ADA Curb Ramp New Construction Inspection Form (Perpendicular)

Nw 289th

24952.54

Nw Kaye

PERPENDICULAR RAMP (PR)

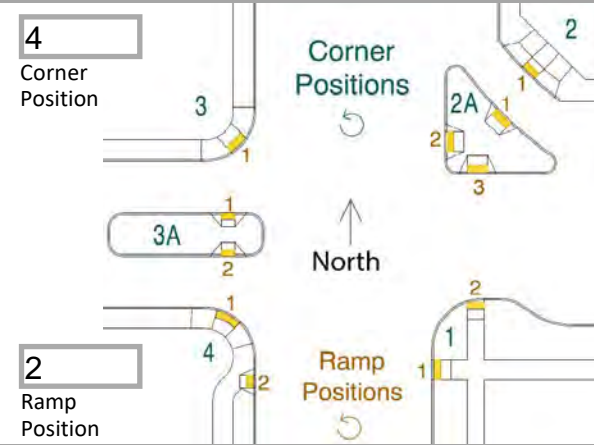
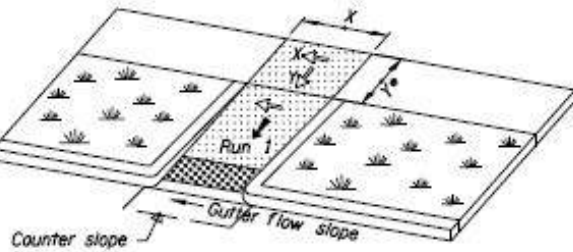
RR1 ICRR, IITD
